## Batteries Not Included (re. ExQ1.3.5)

Can PVDP please provide its estimate of the battery capacity required to support the Botley West farm when it is operating at its design output (840 MWe)?

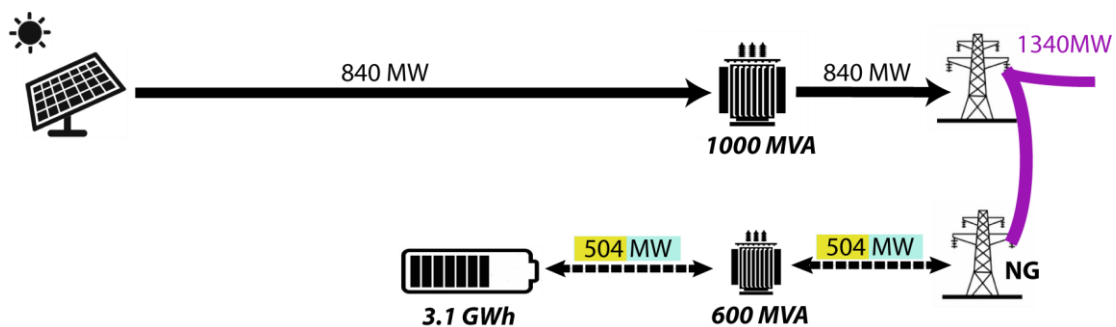
There are two options for the location of a 3.1 GWh battery: **remote** or **co-located**.

The **remote** configuration is the 'do nothing' option. A third-party (or multiple third parties) will construct the 3.1 GWh of BESS(s) elsewhere on the grid.

The battery's grid connection will be at least 500 MW in order to receive BWSF's surplus energy generation.<sup>3</sup>

Thus, NG's HV capacity will have to be 1340 MW (840 + 500) to support this solar/battery configuration, on top of whatever else is on this HV circuit.

In the **co-located** configuration ('AC coupled'), the battery is integrated into the solar farm's circuitry.

NG's required additional HV capacity could be 380 MW (i.e. less than the current 840 MW). Furthermore, the substation capacity will be around 450 MVA rather than 1600 MVA (1000 + 600) for the remote option – a substantial saving in both cost and land-take for the supporting infrastructure (transformers etc.).

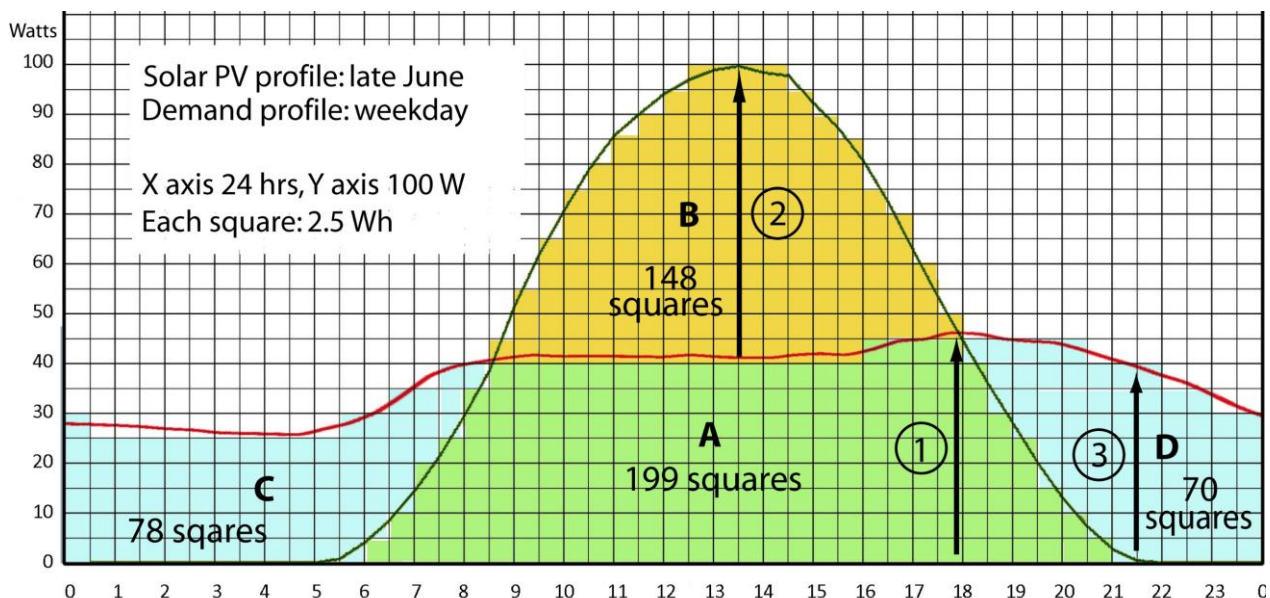
**(a)** Peak solar generation is in late June. A clean profile (i.e. cloud-free day) was copied from <https://www.energydashboard.co.uk> (accessed 10.06.25) and transferred to graph paper (green trace). The axes were labelled for 24 hours and 100 W.

A second profile (red) was obtained for typical 24-hour grid demand. This profile was superimposed and scaled (up and down) until the areas under the two curves were identical. (Area under a Power–Time curve is Energy.)

$$A + B = A + C + D = 347 \text{ squares.}$$

Region A represent solar energy that is supplied directly to the grid.

Region B is the surplus energy to store in the battery. 148 squares is  $148 \times 2.5 = 370 \text{ Wh}$ .

100 W (peak) of summer solar PV generation requires a battery capacity of 370 Wh.
